Use Replacement Clamp

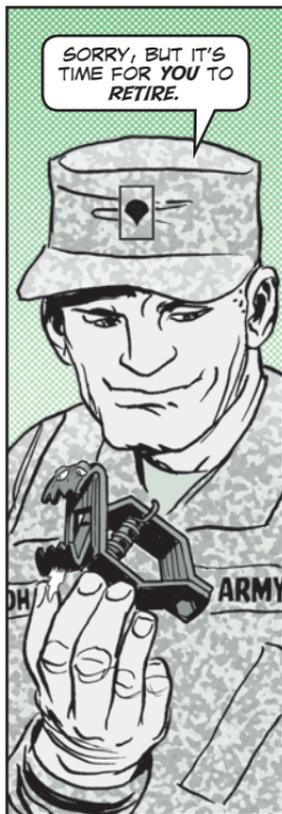
I'm with FMS #4 in Santa Rosa, CA. Our unit just received four new -A4 HEMTT tankers with the old-style ground wire clamps.

These old-style ground wire clamps are known to fall apart from rust and broken springs.

Is there a better clamp in the supply system?

Order a new, durable clamp that comes with NSN 5999-00-134-5844. The new clamp is a snap to install.

Just remove the old clamp, snip off the wire eyelet if there is one, and fit the wire into the new clamp. Use a $\frac{3}{32}$ -in hex wrench from the General Mechanic's tool set to tighten the clamp's handle screws to the ground wire.
